ALERT SERVICE BULLETIN

CHECKING OF THE CRANKSHAFT JOURNAL (POWER TAKE OFF SIDE) FOR ROTAX® ENGINE TYPE 912 AND 914 (SERIES)

ASB-912-059

ASB-914-042

Fig. 1
crankshaft journal

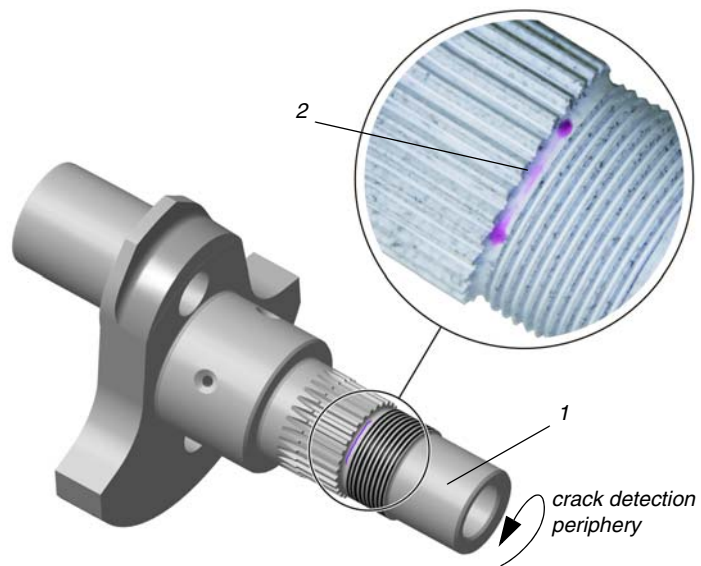
See fig. 1.

- Detailed crack detection in the area (2) of the thread runout using penetration test. Perform this test in accordance to the requirements of the applicable aviation authority in your region for non destructive testing (NDT) and according to DIN EN 571 or equivalent.

- ◆ NOTE: Protect the crankcase against contamination by the test material.
 - CAUTION: In case of crack or doubt contact your aircraft manufacturer and your nearest authorized ROTAX aircraft engine distributor. The engine must not be taken into operation until the cause has been identified and eliminated.
